THE MARYLAND-NATIONAL CAPITAL PARK AND PLANNING COMMISSION

REVIEW TYPE: Preliminary Plan Review

APPLYING FOR: Resubdivision of Lots 3 and 4 Block 18, Glen Echo Heights

CASE #: 1-04008

TAX MAP OR 363
 WEST07 RW 06
PRELIMINARY SUBDIVISION PLAN
LOTS 36, 37 & 38 BLOCK 18
GLEN ECHO HEIGHTS
 13TH ELECTION DISTRICT - MONTGOMERY COUNTY - MARYLAND

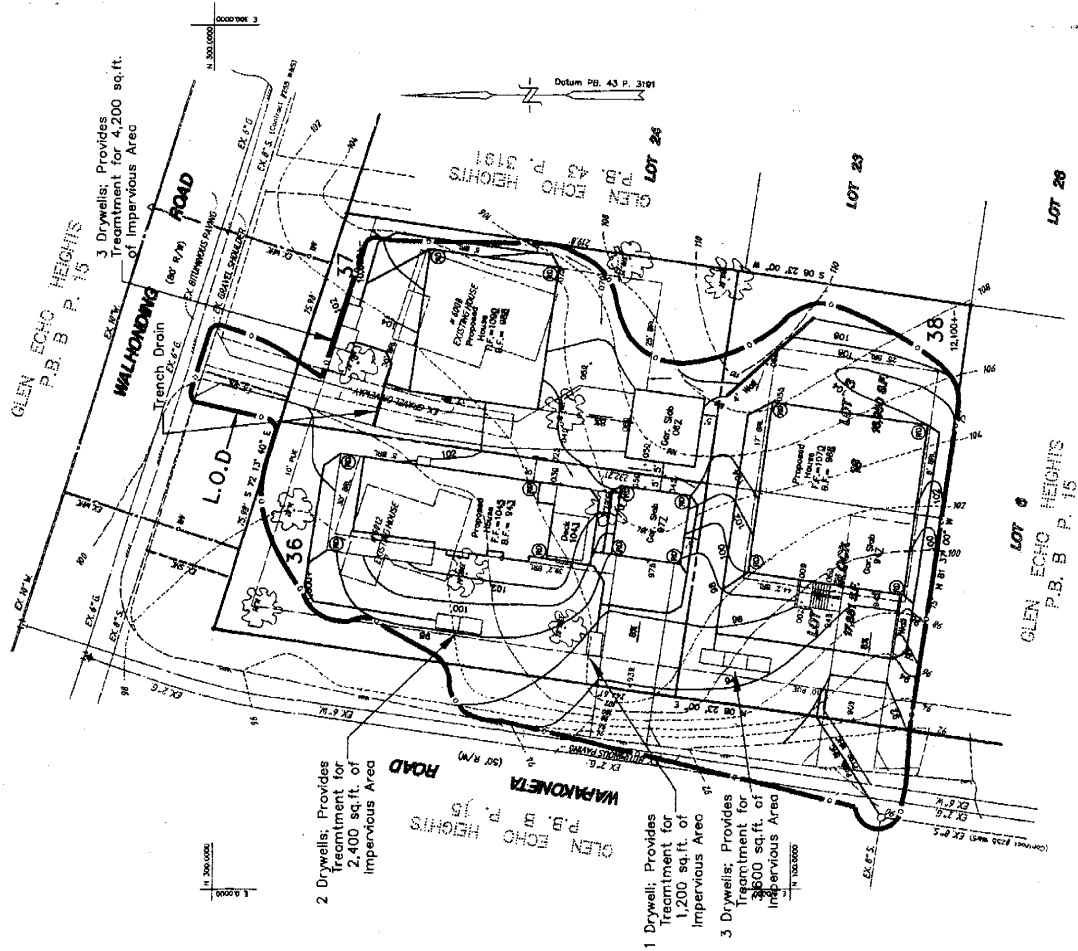
- (1) Provide revised preliminary plan drawing that reflects a 17-foot side yard setback on the south side of proposed Lot 38 to improve the potential for preservation of existing vegetation and to provide additional buffer for existing house on Lot 6. Northern lot line of proposed Lot 38 shall have an eight foot side yard setback

- (2) Compliance with all recommendations of Final Tree Preservation Plan. A final plan acceptable to staff must be approved prior to recordation of any plat for the subject property. The final plan must be in accord with arborist's recommendations contained in the plan submitted 10/10/03 for saving certain onsite trees (including 54 inch Oak tree on proposed lot 37), protecting off site trees; and additionally, the final plan must address all staff comments of the 11/07/03 Environmental Planning memo, including maximizing house setback and minimizing grading along the southern property line of proposed lot #38
